RESIDENTIAL 1 & 2 FAMILY PERMIT

05-136461-REV-01-RS

PROJECT INFORMATION		Occ. Group	Const. Type
Single Family Dwelling	New Construction	R3	V-N
Project Description: REVISION 6/16/06 - CHANGE FRONT ENTRY DESIGN

☐ Conference Project: Kiraly Residence
☐ Phone Subject: Revised Entry (FOUNDATION PLAN)
☐ Field With: SUPPORTING CALCS C1-C8
☐ Memo To: Michaeline Kiraly
☐ Job Observation By: SAE
☒ Revision Sketch Distribution: - - -

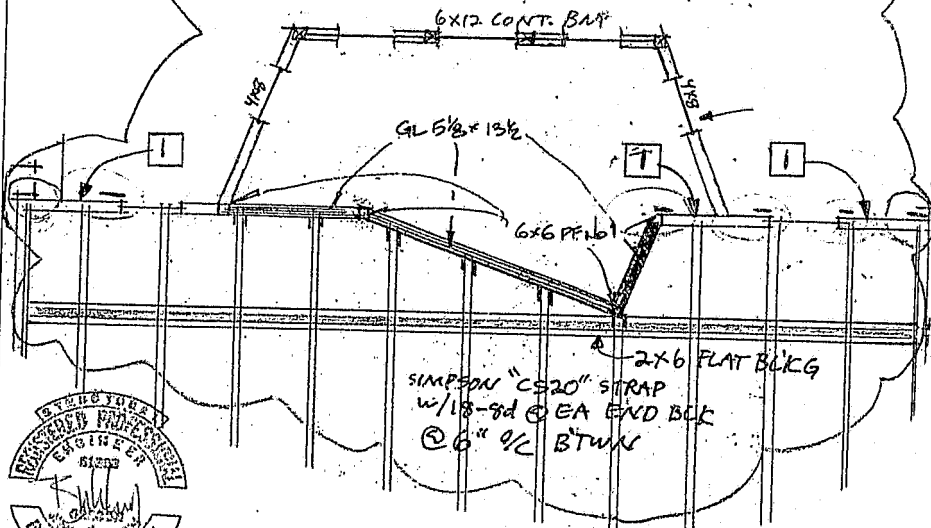
11" SIMPSON "MSTC40"
 (AT FLR-FLR CONNECTION)
 KING STUD & TRIMMERS MUST
 ALIGN FLR-FLR.

1 1 1/2" APA WALL SH'TG
 w/10d @ 6" O.C. - EDGES
 @ 12" O.C. - FIELD

☐ Conference	Project: Kiraly Residence	Job No.: 05-277
☐ Phone	Subject: Revised Entry (SECOND FLOOR PLAN)	Date: June 27, 2006
☐ Field	With: SUPPORTING CALLS C1-C8	Time: -
☐ Memo	To: Michaeline Kiraly	By: SAE
☐ Job Observation	By: SAE	Ref. Sheet:
☒ Revision Sketch	Distribution: -	Sheet #: R2

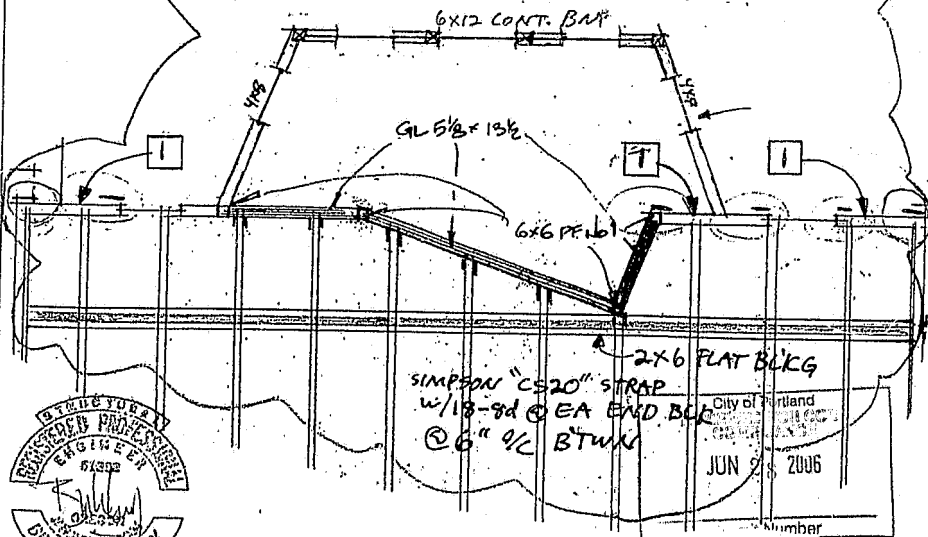
1" SIMPSON "ASTC40"
(AT FLR-FLR CONNECTION)
KING STUD + TRIMMERS MUST
ALIGN FLR-FLR.

1 1 1/2 APA WALL SH'TG
w/10d @ 6" $\varnothing$ - EDGES
@ 12" $\varnothing$ - FIELD

1 SECOND FLOOR PLAN
3x SCALE: $\frac{1}{4}" = 1'-0"$

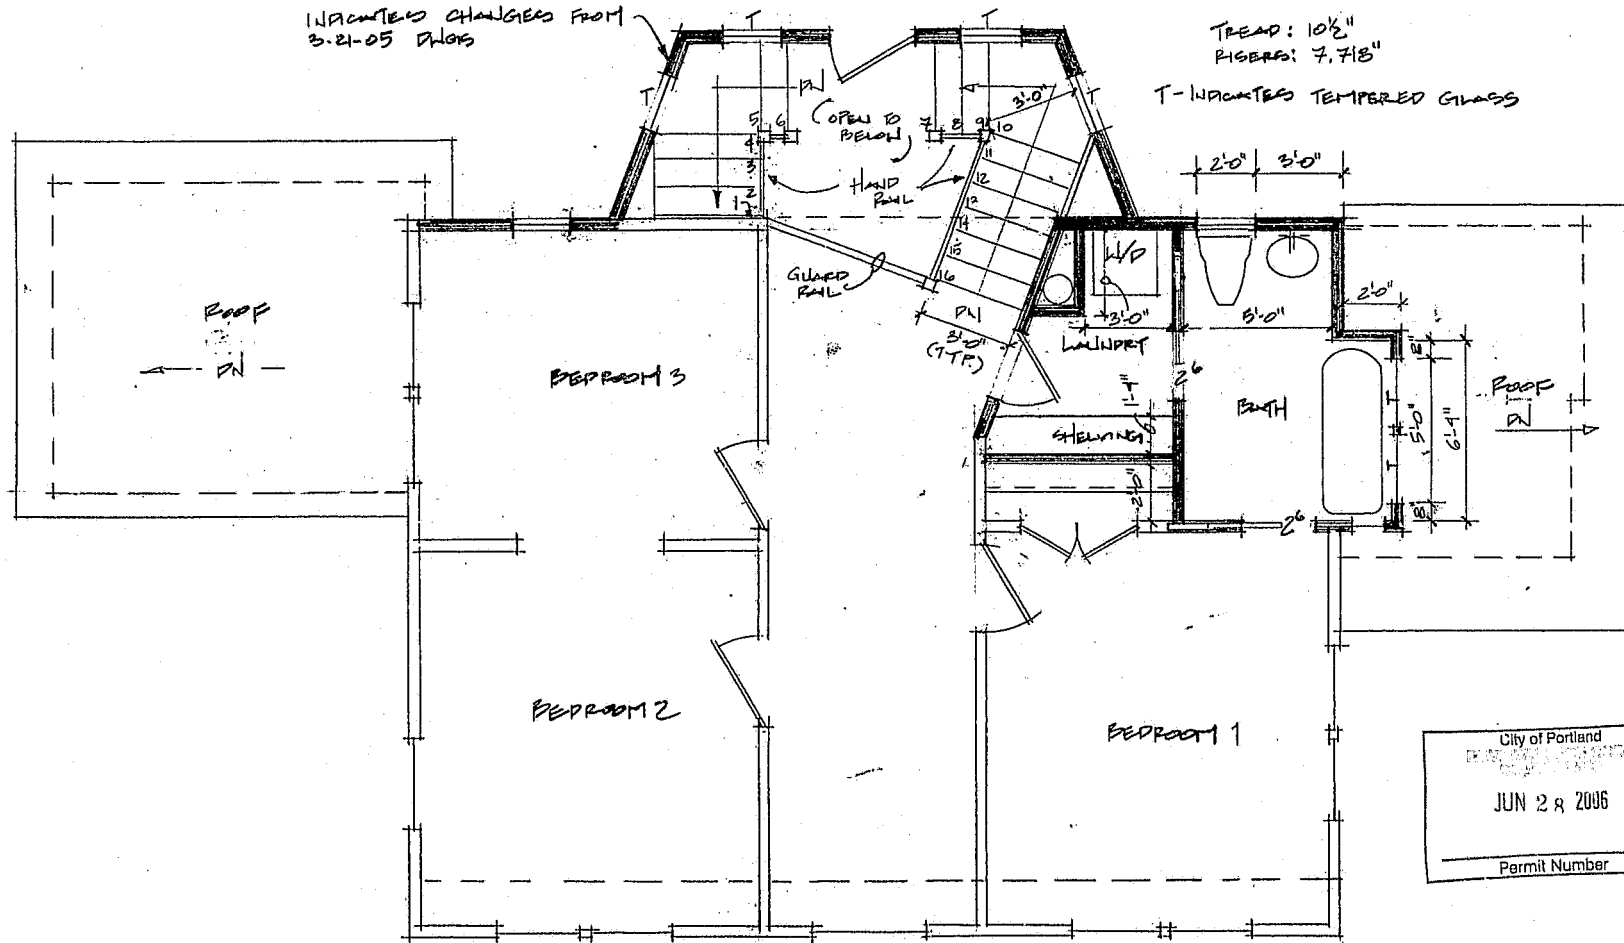
INDICATED CHANGES FROM
3-21-05 DWGS

STAIRS

TREAD: $10\frac{1}{2}"$
RISER: $7.718"$

SECOND FLOOR FRAMING PLAN

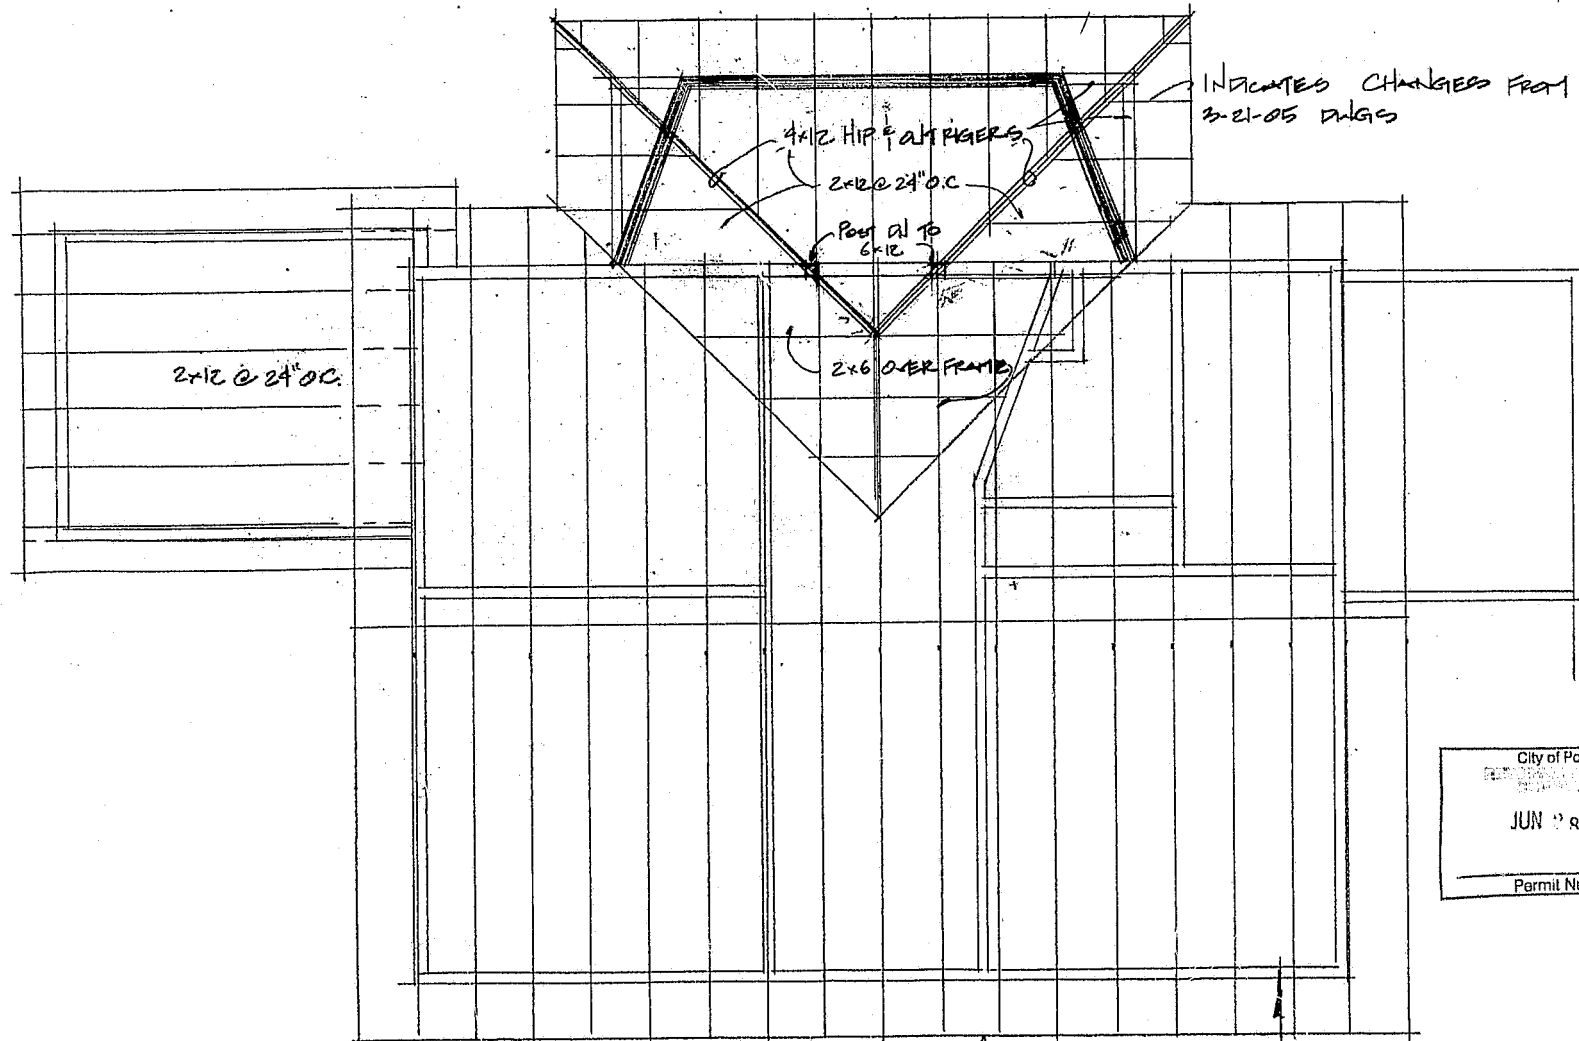
INDICATED CHANGES
FROM 3-21-05 REVISED.

GL 5 1/8" = 13 1/2"

6x6 PFT 101

#1 PF 4x14 @ 32" O.C. SEE SHT 3 OF STRICT CHGS.
W/ CAR DECK
